GASKET, RUBBER, FLUID RESISTANT,
OILS, SYNTHETIC OILS AND FUELS
(-65 TO +400 °F), MOLD IN GROOVE

SAE AS27196A
SHEET 1 OF 2

FIGURE 1

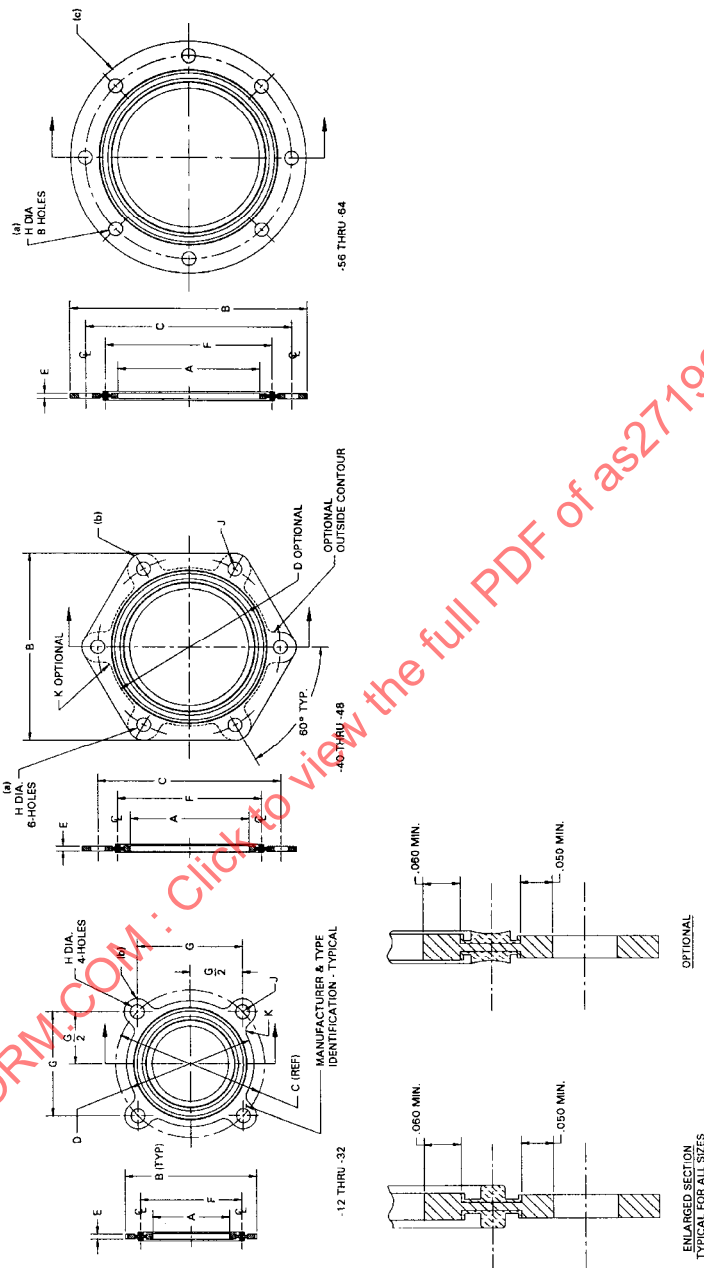
WHEN MS27196 WAS CONVERTED TO AS27196 THE PLATE MATERIAL WAS UPDATED FROM MIL-S-5059 302 ANNEALED TO AMS 5515. MIL-S-5059 CANCELLATION NOTICE 1 STATES THAT 302 ANNEALED WAS REPLACED BY AMS 5516. THIS REVISION CORRECTS THAT ERROR.
